**UNITED STATES DEPARTMENT OF COMMERCE
Patent and Trademark Office**

09/181,126 10/28/98 ROHS U ROHS-6

Office Action Summary

DETAILED ACTION

In regards to claim 1, in figures 1 and 2 below, Sudau discloses

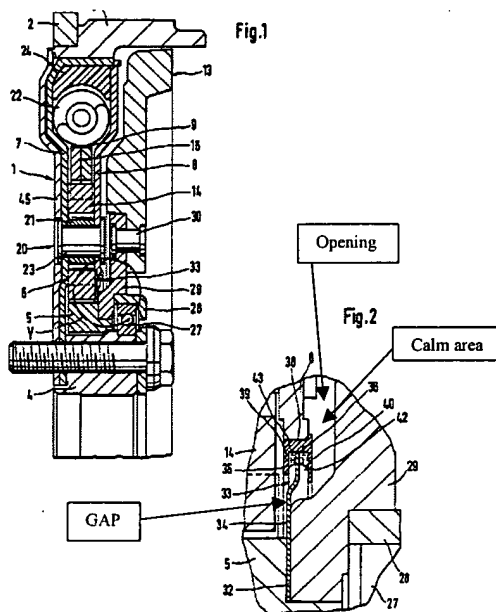
Claims 1, 4-10 and 17 are rejected under 35 U.S.C. 102(e) as being anticipated by US patent 5911628, Sudau.

a torsional vibration damper

comprising two modules (1,13) that rotate in relation to each other, and a spring chamber (22), the first module (1) having a first guide surface (36) and sealing the spring chamber radially outward, whereby the first guide surface is at a distance from the second module (13) across a gap and is essentially radial, and further comprising an essentially radial second guide surface (34) which covers the gap on the spring chamber side.

In regards to claim 4, in figures 1 and 2 above, Sudau discloses the second guide surface being designed as a guide disk.

In regards to claim 5, in figures 1 and 2 above, Sudau discloses the guide being in the shape of a washer.

In regards to claim 6, in figures 1 and 2 above, Sudau discloses the guide disk being fixed to the first guide surface.

In regards to claim 7, in figures 1 and 2 above, Sudau discloses between the first guide surface and second guide surface there is provided at least one opening (42) that faces the spring chamber.

In regards to claim 8, in figures 1 and 2 above, Sudau discloses the opening being situated so that a particle moving radially can pass through.

In regards to claim 9, in figures 1 and 2 above, Sudau discloses between the first and second guide surfaces close to the gap there is provided a calm area that is situated between the first guide surface and the second module.

In regards to claim 10, in figures 1 and 2 above, Sudau discloses the calm area having an opening extending radially outward that leads to the spring chamber.

In regards to claim 17, in figures 1 and 2 above, Sudau discloses a grease transporting system activated by centrifugal force.
